Conditional Final Plat Checklist

CONDITIONAL FINAL PLAT

HACKBERRY MARKET

DATE: 2/24/2025
HACKBERRY MARKET
PUD-001818-2024
CONDITIONAL FINAL PLAT
SHEET 1 OF 3

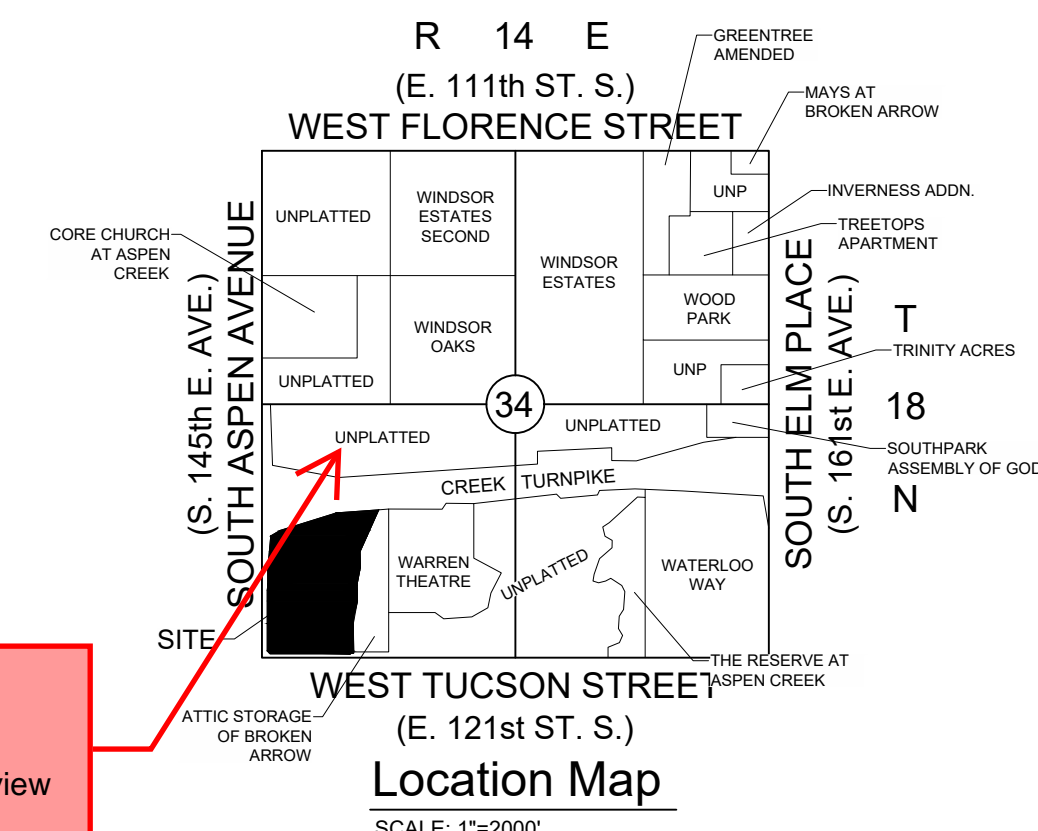
P01
Revise the location map to show the platted Aspen Ridge Business Park
This was identified in the preliminary plat review and has not been addressed.

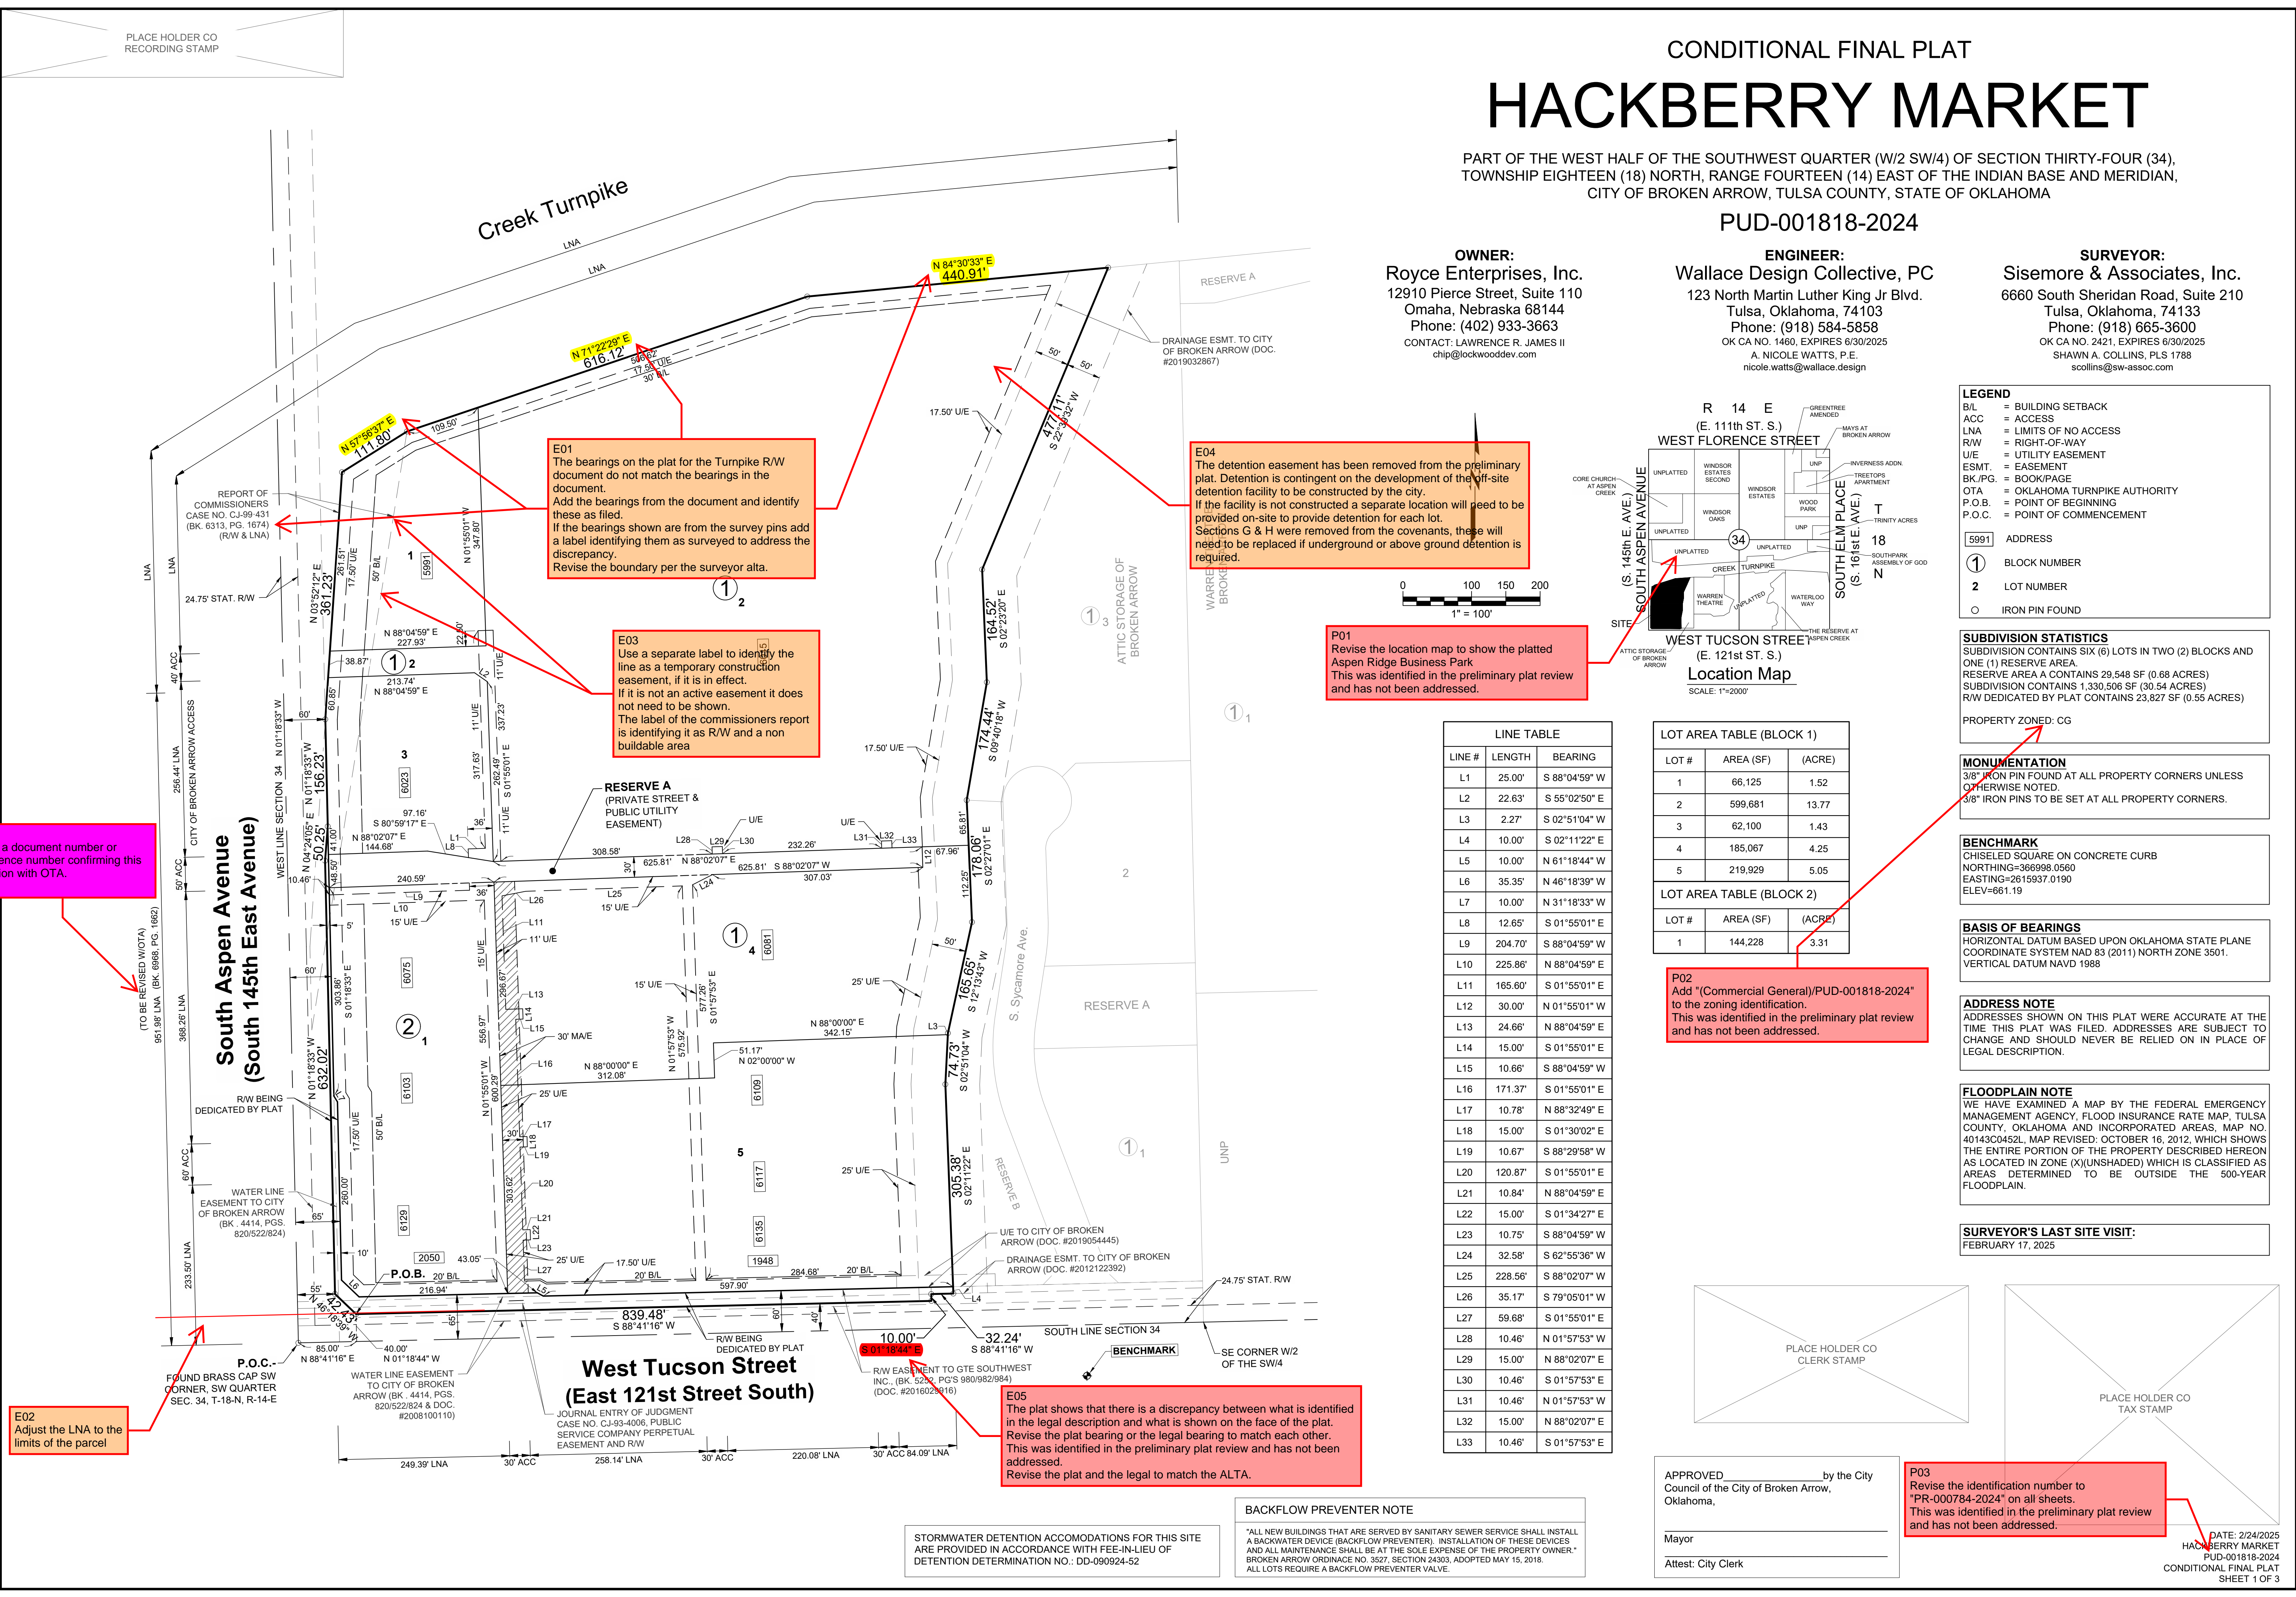
E01
The bearings on the plat for the Turnpike R/W document do not match the bearings in the document.
Add the bearings from the document and identify these as filed.
If the bearings shown are from the survey pins add a label identifying them as surveyed to address the discrepancy.
Revise the boundary per the surveyor alta.

E02
Adjust the LNA to the limits of the parcel

E03
Use a separate label to identify the line as a temporary construction easement, if it is in effect.
If it is not an active easement it does not need to be shown.
The label of the commissioners report is identifying it as R/W and a non buildable area

E04
The detention easement has been removed from the preliminary plat. Detention is contingent on the development of the off-site detention facility to be constructed by the city.
If the facility is not constructed a separate location will need to be provided on-site to provide detention for each lot.
Sections G & H were removed from the covenants, these will need to be replaced if underground or above ground detention is required.

E05
The plat shows that there is a discrepancy between what is identified in the legal description and what is shown on the face of the plat.
Revise the plat bearing or the legal bearing to match each other.
This was identified in the preliminary plat review and has not been addressed.
Revise the plat and the legal to match the ALTA.

P02
Add "(Commercial General)/PUD-001818-2024" to the zoning identification.
This was identified in the preliminary plat review and has not been addressed.

P03
Revise the identification number to "PR-000784-2024" on all sheets.
This was identified in the preliminary plat review and has not been addressed.

P05:
Note a document number or reference number confirming this revision with OTA.
